MARKED	REVISION	DATE
A

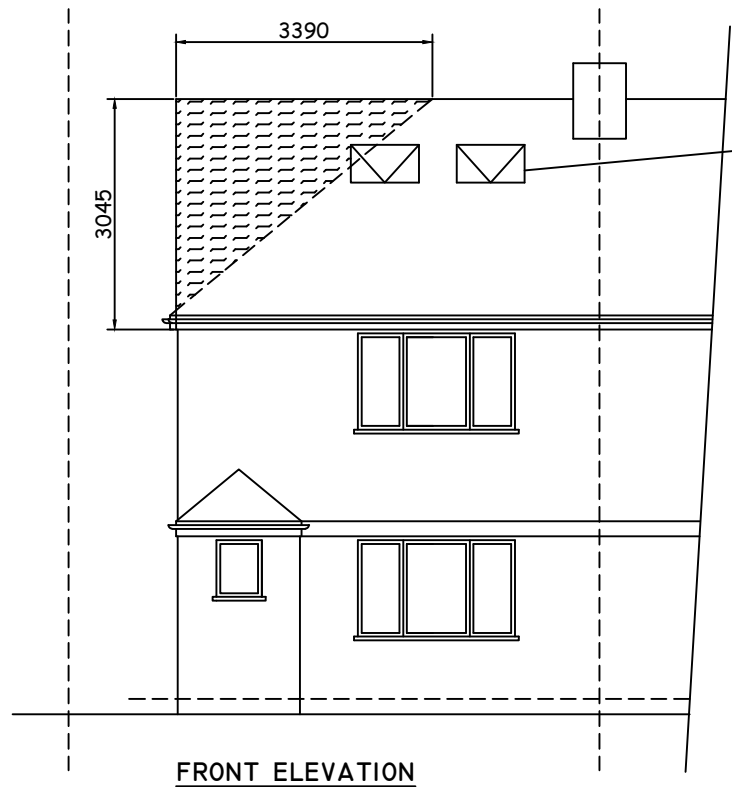
ROOF LIGHT NOT TO
PROTRUDE 150MM BEYOND
THE ROOF SLOPE

TILES TO MATCH
EXISTING

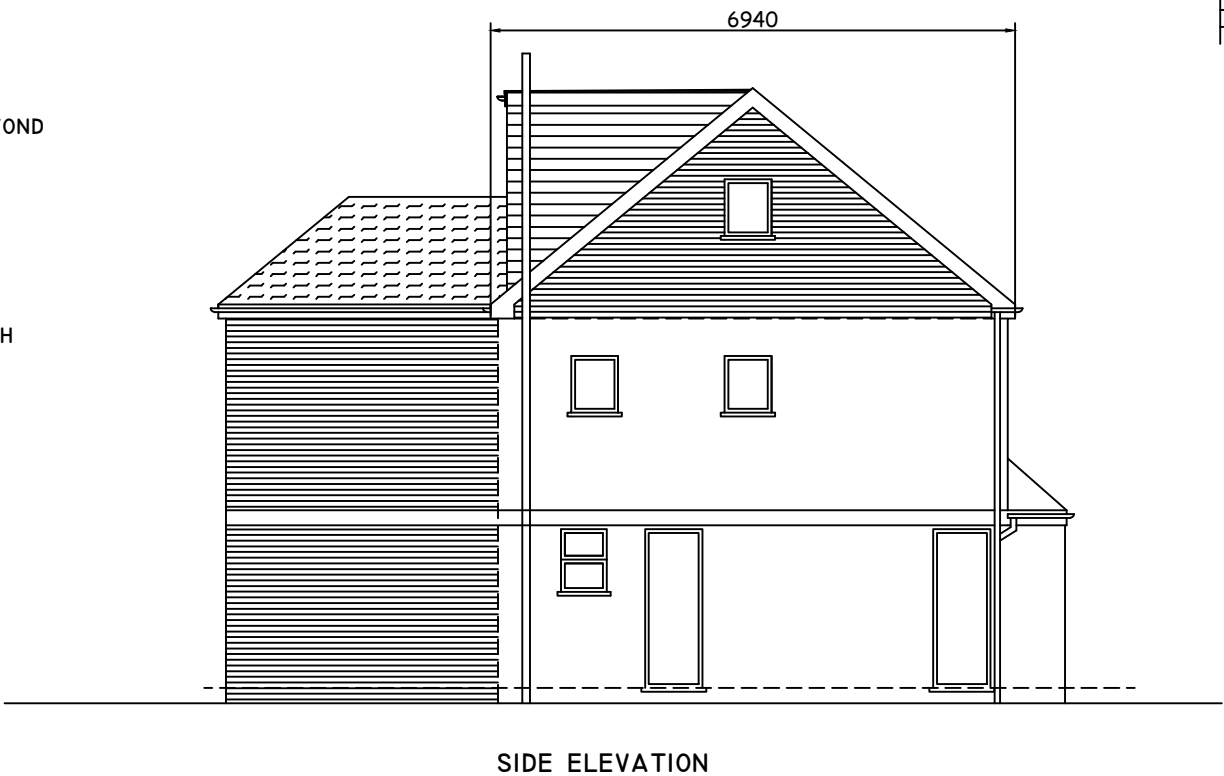
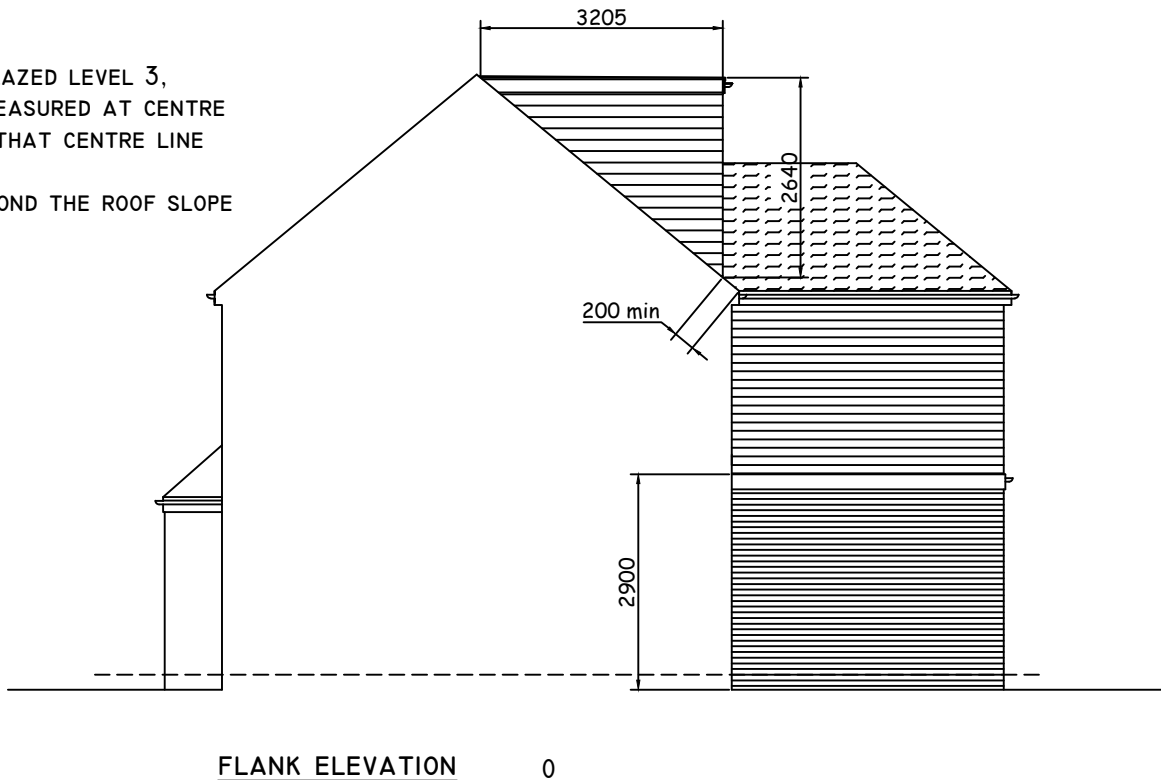
BRICK WORK TO MATCH
EXISTING

1.WINDOW IN GABLE WALL TO BE OBSCURE-GLAZED LEVEL 3,
AND FIXED SHUT TO 1.7M ABOVE STAIRS - MEASURED AT CENTRE
LINE OF THE WINDOW AND THE STEP BELOW THAT CENTRE LINE
